**SUBJECT: AP1000 COL Standard Technical Report Submittal of APP-GW-GLR-022, Revision 1
(Technical Report Number 8)**

APP-GW-GLR-022, Revision 1

“AP1000 Leak-Before-Break Evaluation of As-Designed Piping”

Technical Report Number 8

Figure 4-4

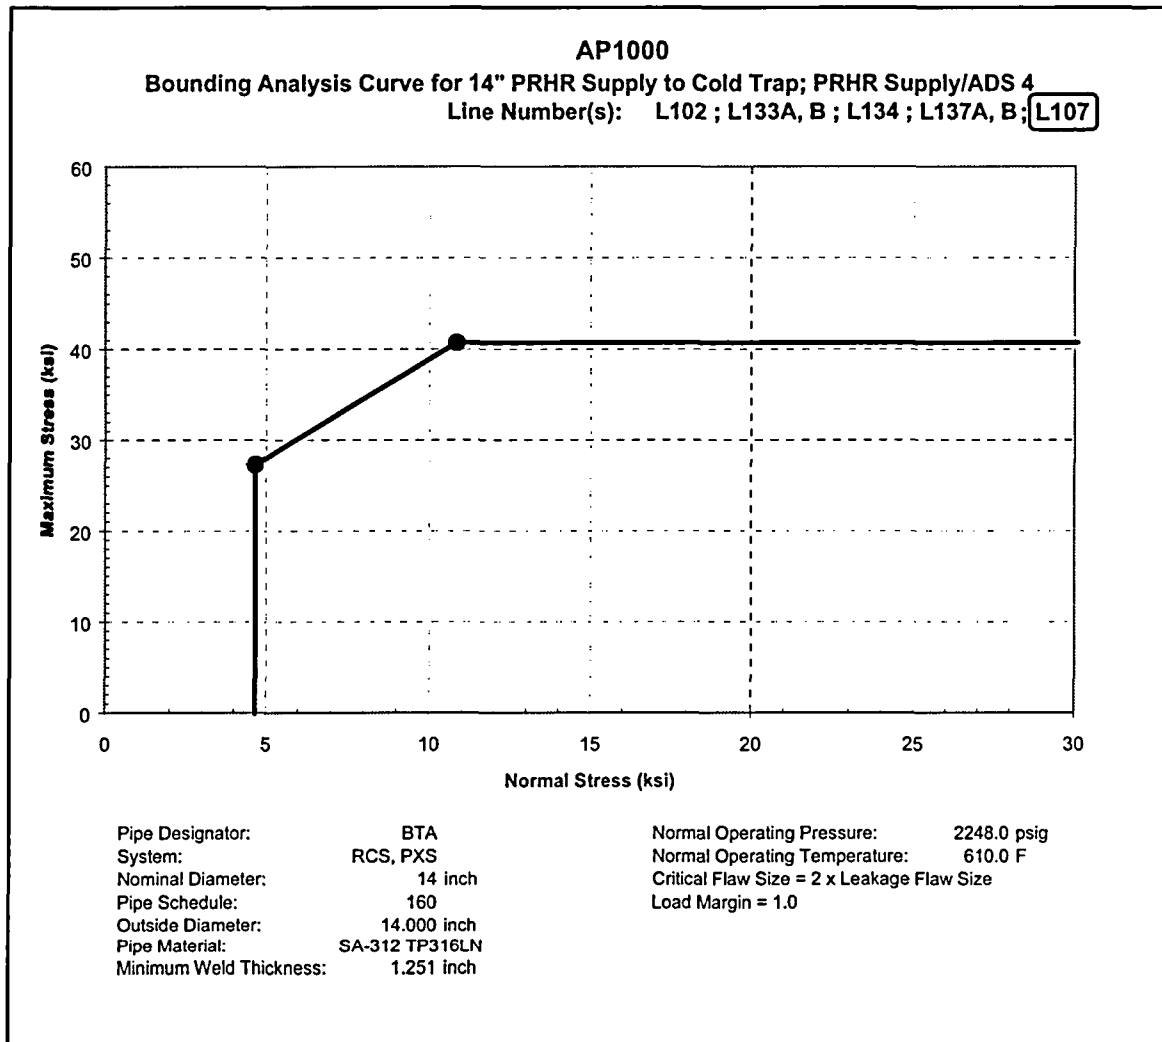
Line L107 is added to DCD Figure 3B-8.

Figure 4-5

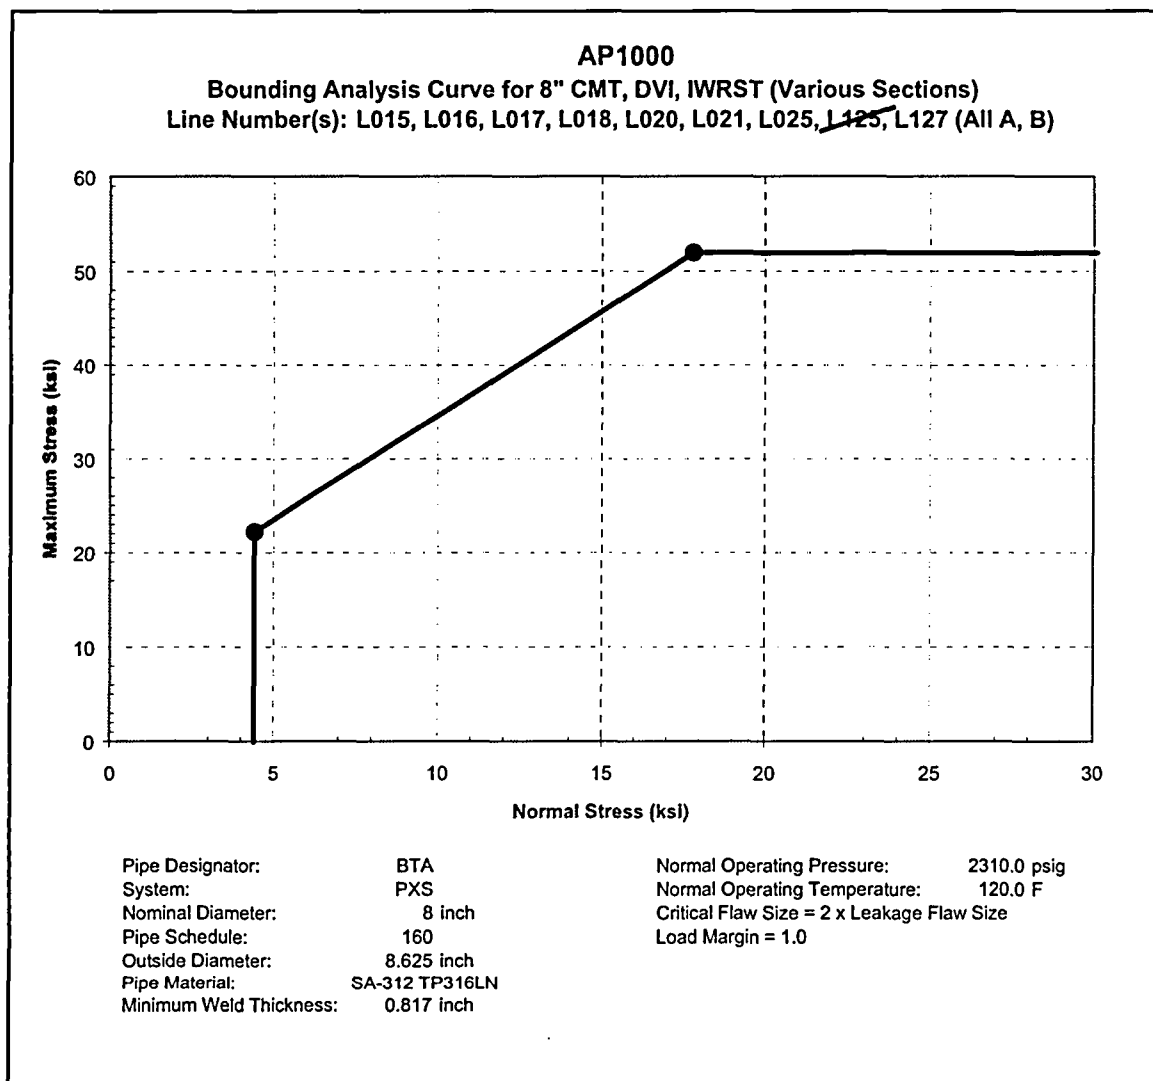
Line L125 is removed from DCD Figure 3B-15 to reflect the move of the line to DCD Figure 3B-14.

Figure 4-6

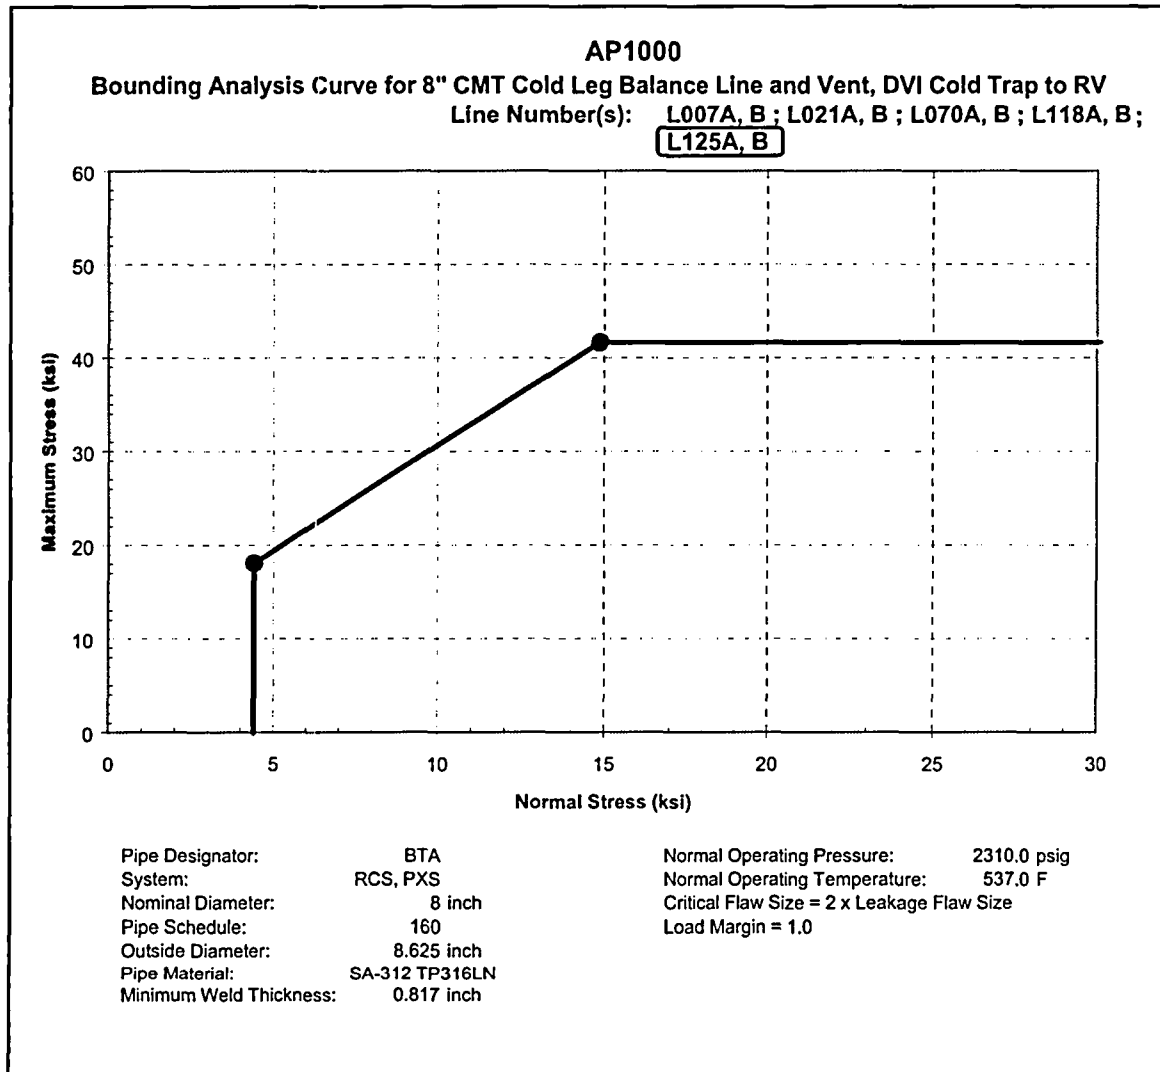
Line L125 (A,B) is added to DCD Figure 3B-14 to reflect the move of the line from DCD Figure 3B-15.

Figure 4-9

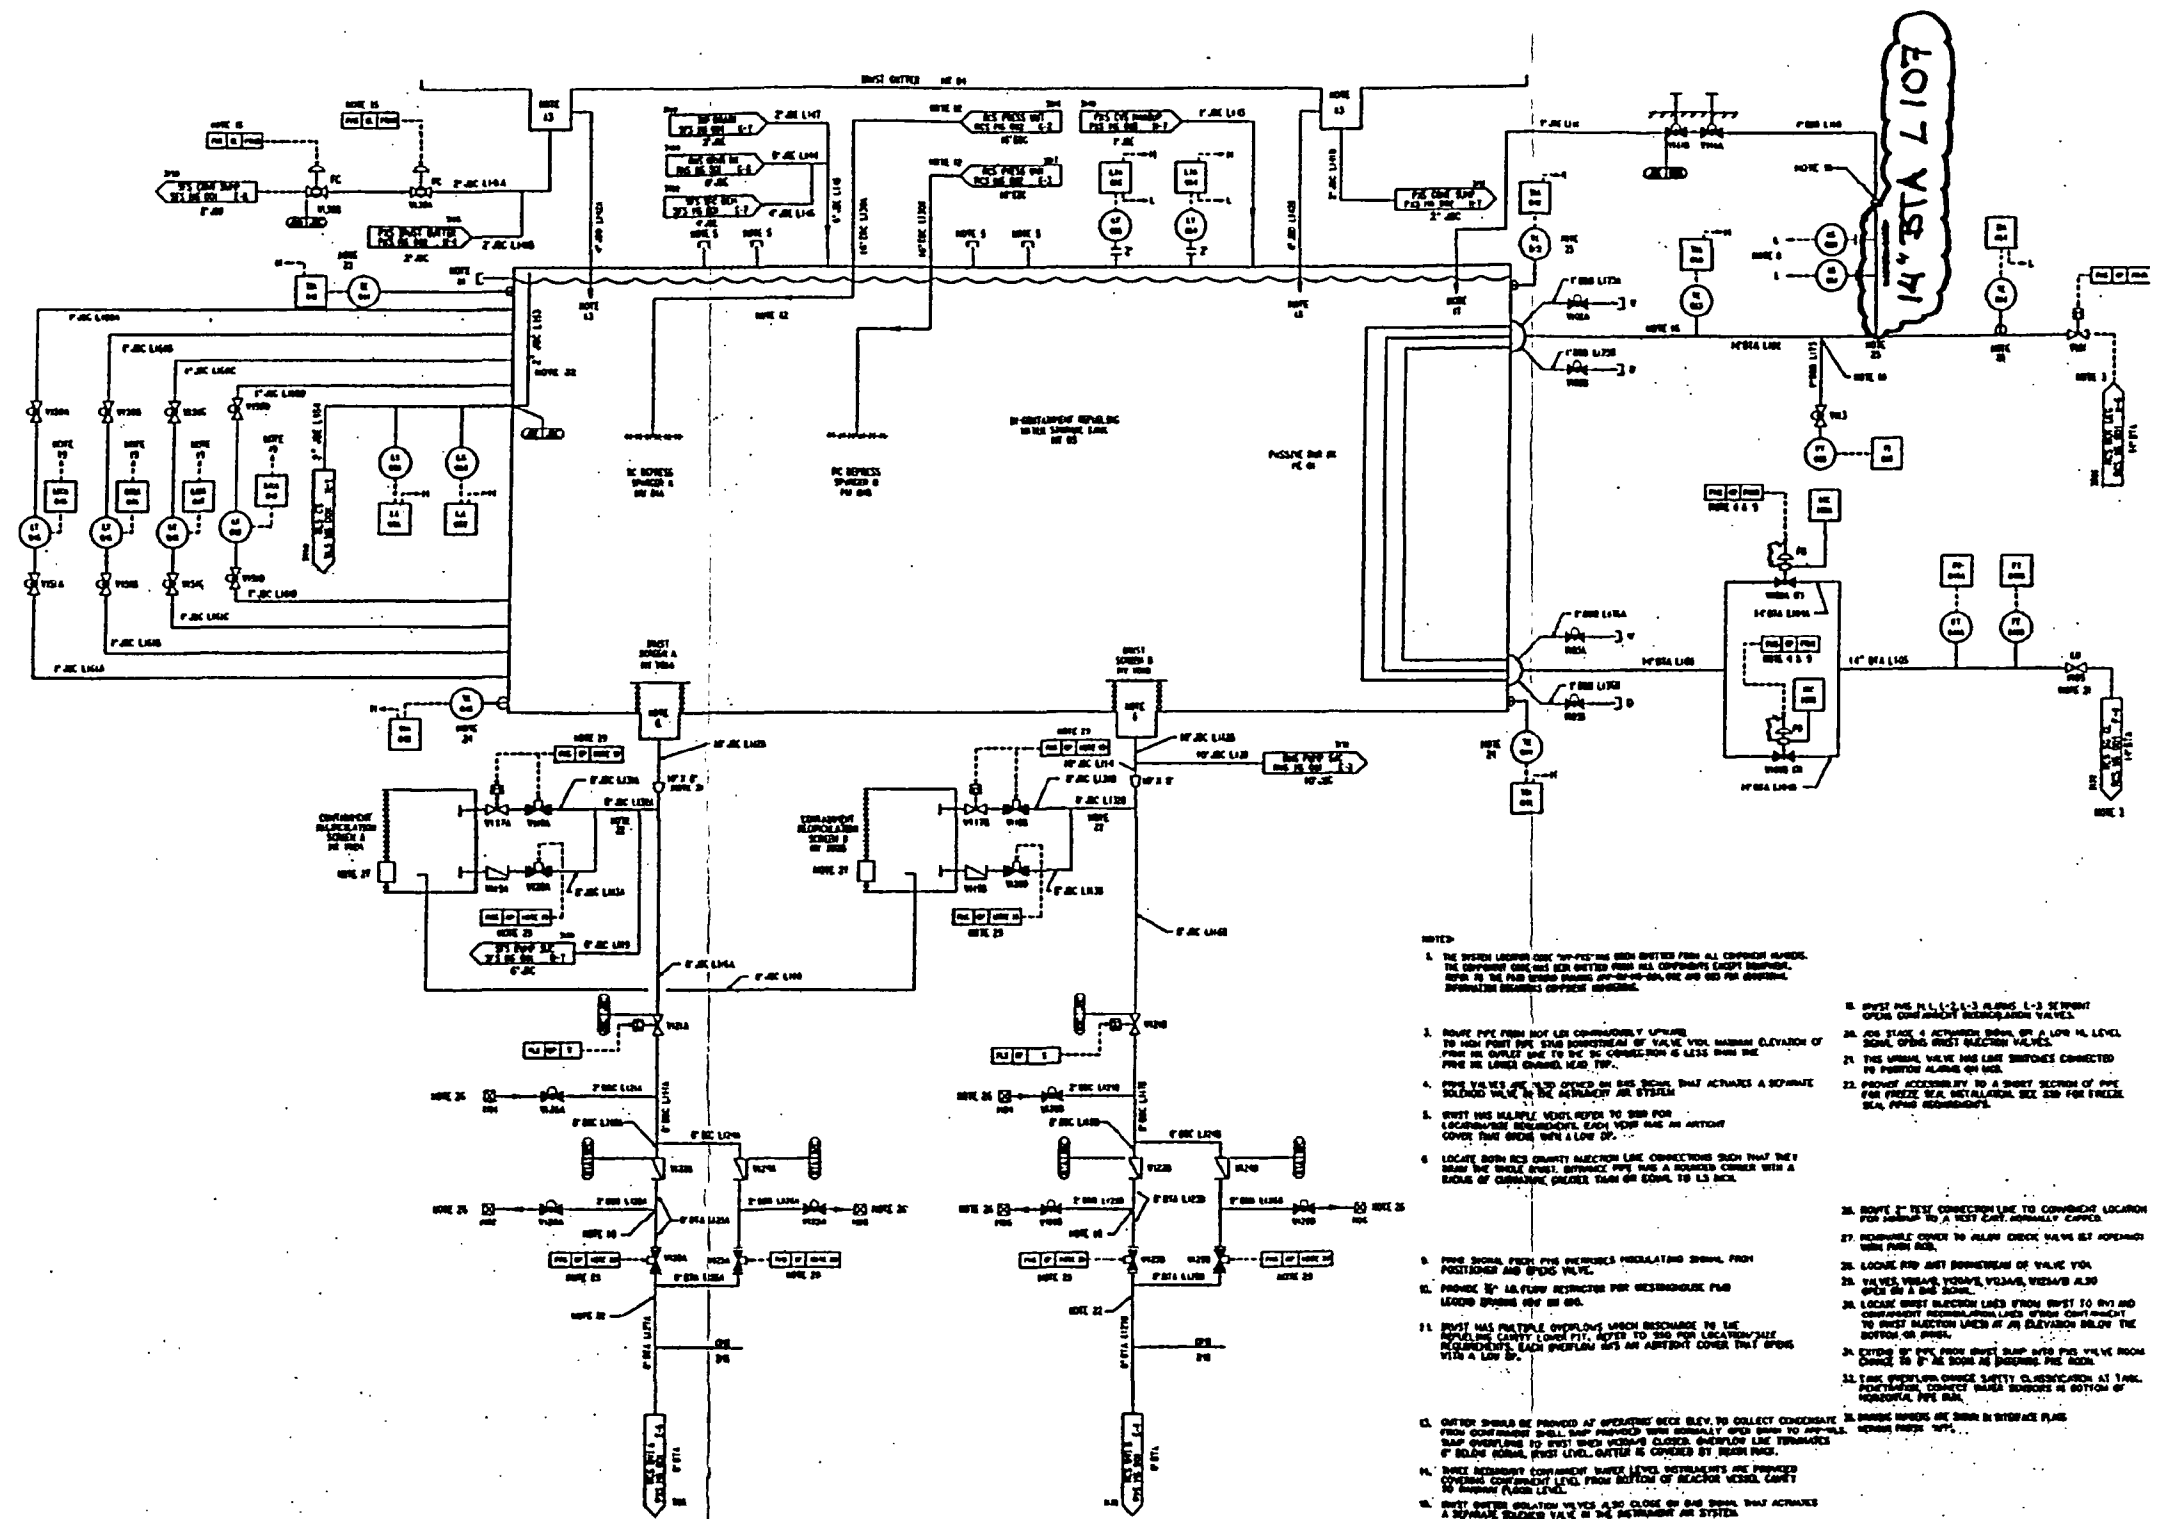
Table 3B-1 of the DCD is revised to reflect the proper diameter (14") of the Passive Residual Heat Removal Vent Line (PXS-L107) as part of the Passive Residual Heat Removal Supply to Cold Trap, DCD Figure 3B-8. Accordingly, DCD Figure 3B-12 is marked as unused and the entry in DCD Table 3B-1 involving this DCD Figure is marked unused. An addition has been made to the description of DCD Figure 3B-8 in Table 3B-1 to indicate the inclusion of the Vent Line. The change in diameter has been made to the Passive Core Cooling System-Piping and Instrumentation Diagram (Sheet 2, Figure 6.3-2) in DCD Section 6.3, as well as the High Energy Piping-Passive Core Cooling System (Figure 3E-4) in Appendix 3E.

Change as noted in red.

**Passive Core Cooling System - Piping and Instrumentation Diagram (Sheet 2),
(Revised, DCD Figure 6.3-2)**

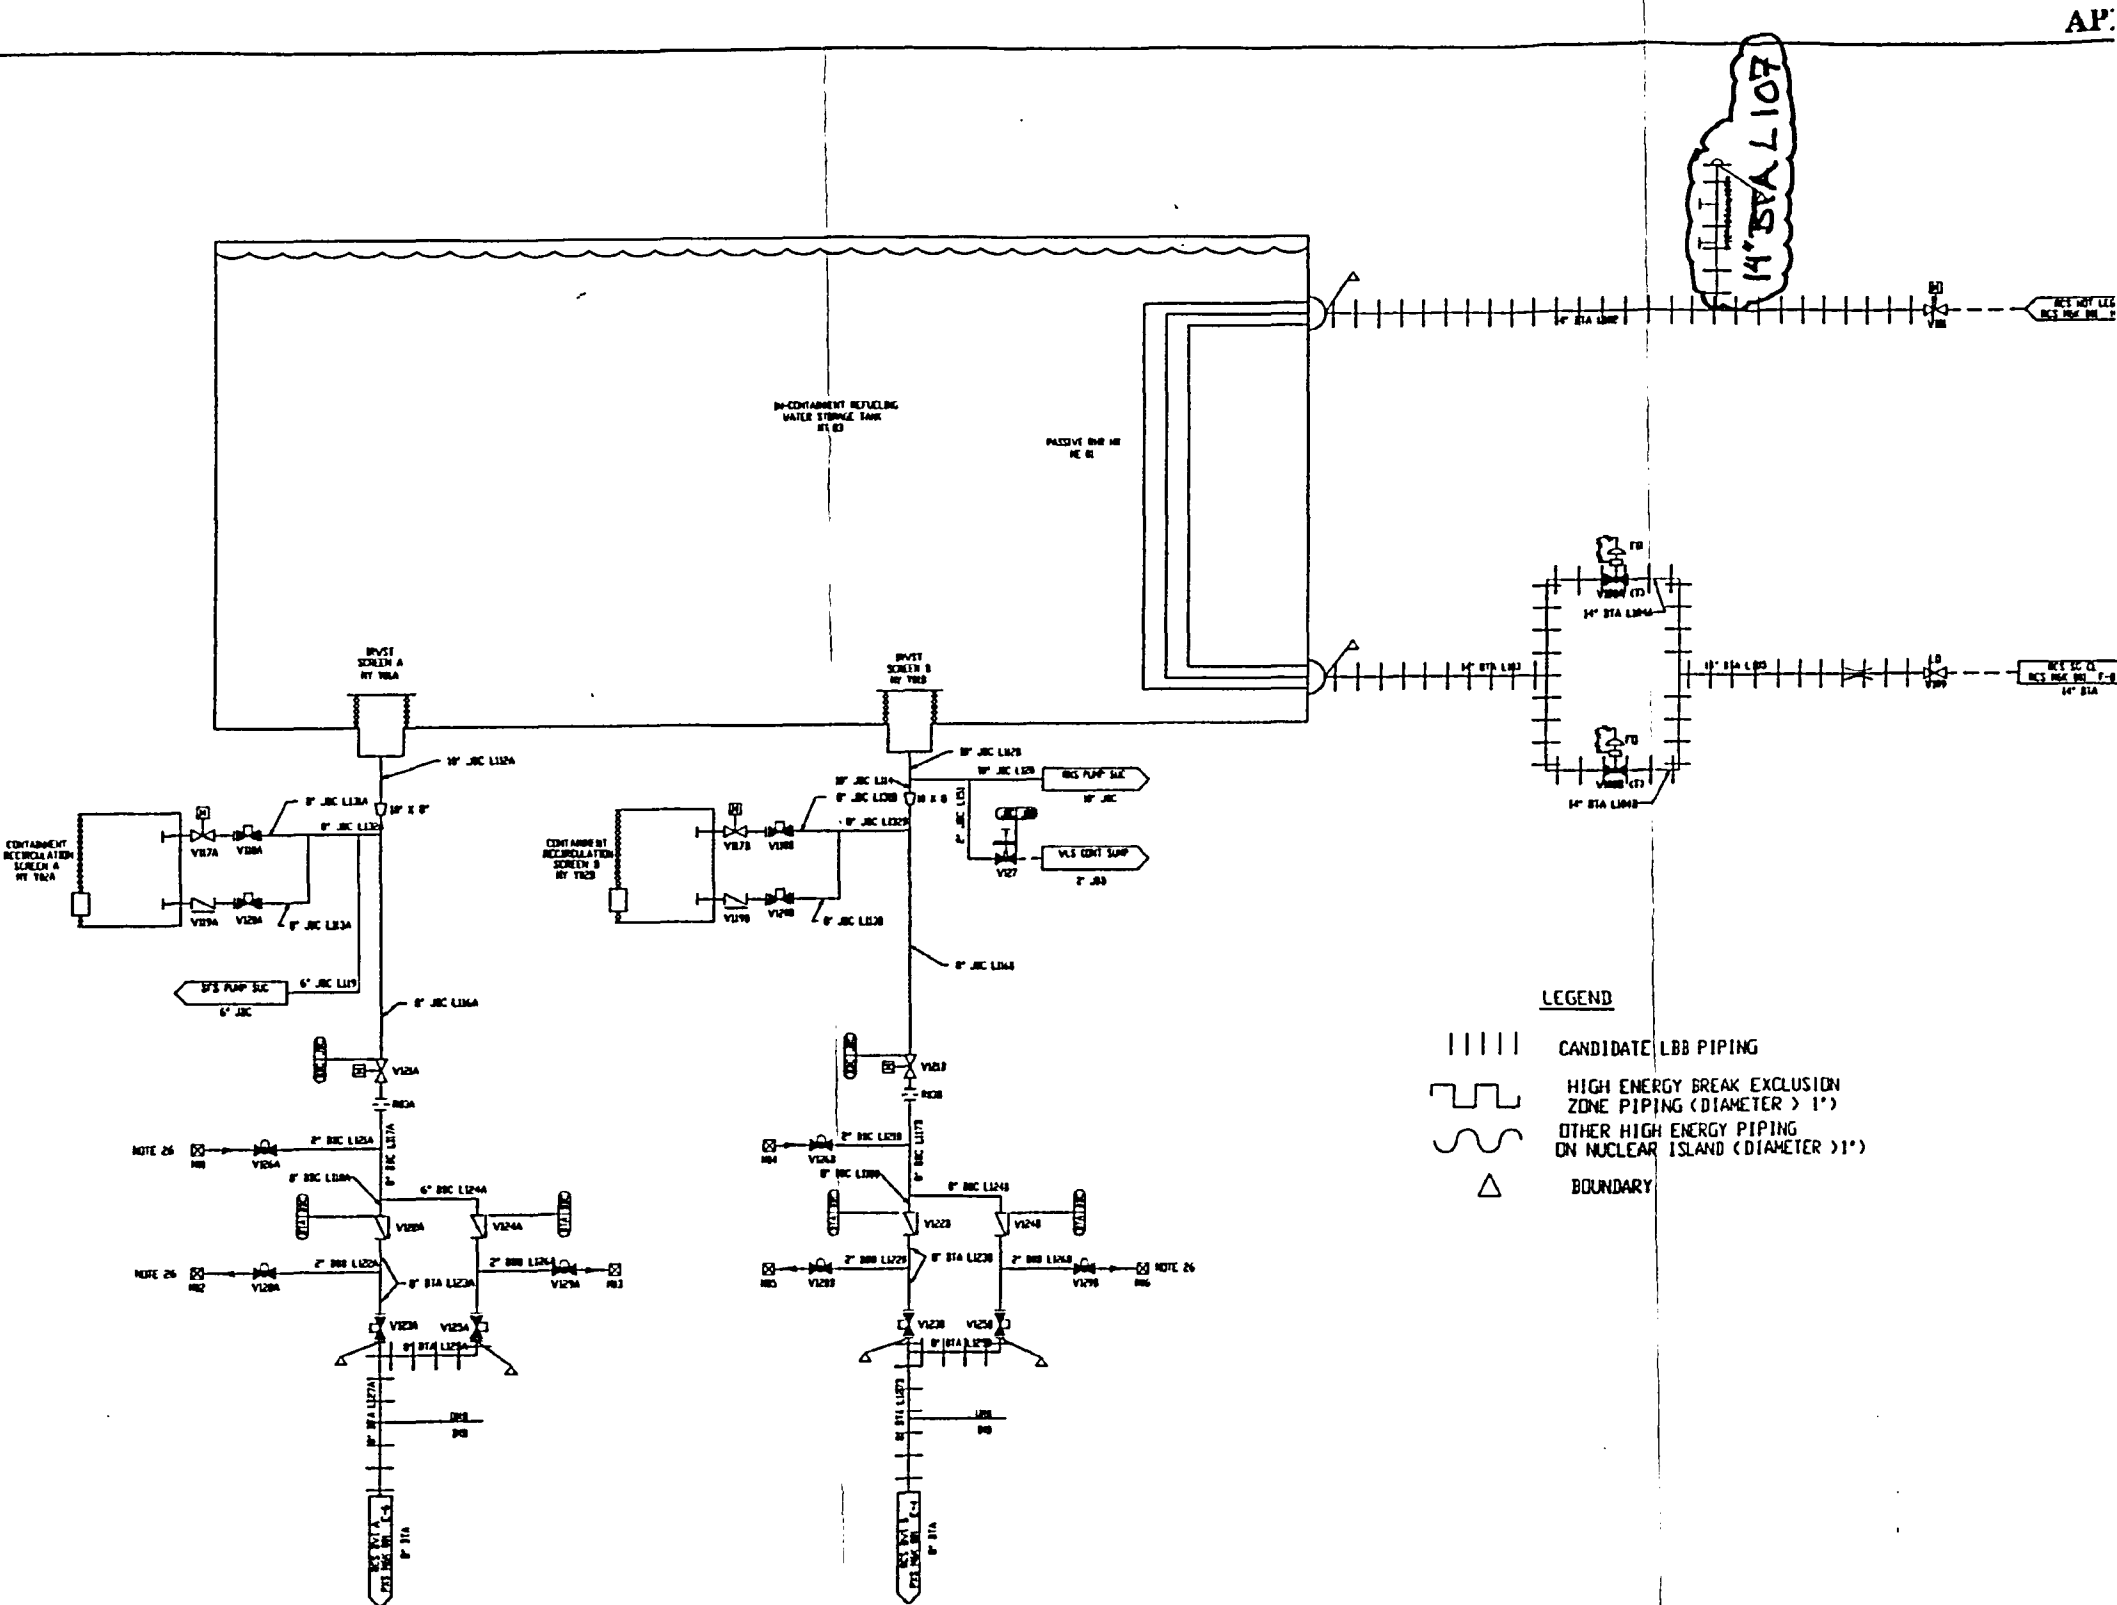
Change as noted in red.
